Access Compliance Report

Public Rights-of-Way

(Curb Ramps)

Intersection ID: 10033070	Main Street: NORTH_COMMUNITY_HOUSE_RD	Cross Street: N/A	Location: NW
ADA ID: 6FCC332E741C	Ramp Type: Perp	Initial Pass/Fail: Fail	Overall Compliance: No
Severity Score: 12.5			
Codes/Mitigation Info/Possible Solution		Field Measurements/Component Compliance

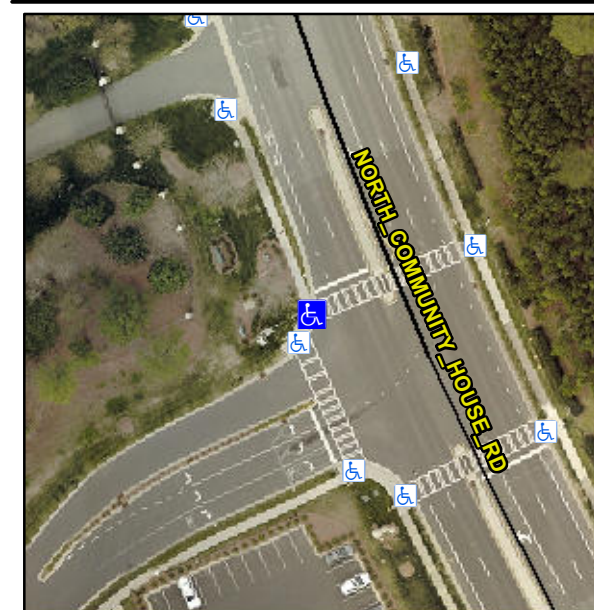
R304.2.2

Compliance	Description	Data	Compliance	Description	Data
N/A	Ramp Length (in)	26.5	No	Ramp Slope (%)	11.0
Yes	Ramp Width (in)	48.0	Yes	Ramp XSlope (%)	1.8
N/A	Flare Type LT	N/A	N/A	Flare Type RT	N/A
N/A	Flare Slope LT (%)	N/A	N/A	Flare Slope RT (%)	N/A
N/A	Flare Traversable LT?	N/A	N/A	Flare Traversable RT?	N/A
N/A	Landing Length (in)	N/A	N/A	DWS Provided?	N/A
N/A	Landing Width (in)	N/A	N/A	DWS Contrast?	N/A
N/A	Landing Slope (%)	N/A	N/A	DWS Length (in)	N/A
N/A	Landing X Slope (%)	N/A	N/A	DWS Full Width?	N/A
N/A	Landing Curb? (Y/N)	N/A	N/A	DWS Offset (in)	N/A
N/A	Shared Landing?	N/A			
N/A	Gutter Ponding?	N/A	N/A	Gutter Slope (%)	N/A
N/A	Gutter Lip Ht (in)	N/A	N/A	Gutter X Slope (%)	N/A
N/A	Painted X Walk1?	Yes	N/A	Painted X Walk2?	N/A
	X Walk 1 Direction	To NE		X Walk 2 Direction	N/A
N/A	X Walk 1 Width (in)	109.0	N/A	X Walk 2 Width (in)	N/A
	X Walk 1 Slope (%)	2.9		X Walk 2 Slope (%)	N/A
	X Walk 1 X Slope (%)	2.1		X Walk 2 X Slope (%)	N/A

Remove & Replace Entire Ramp.
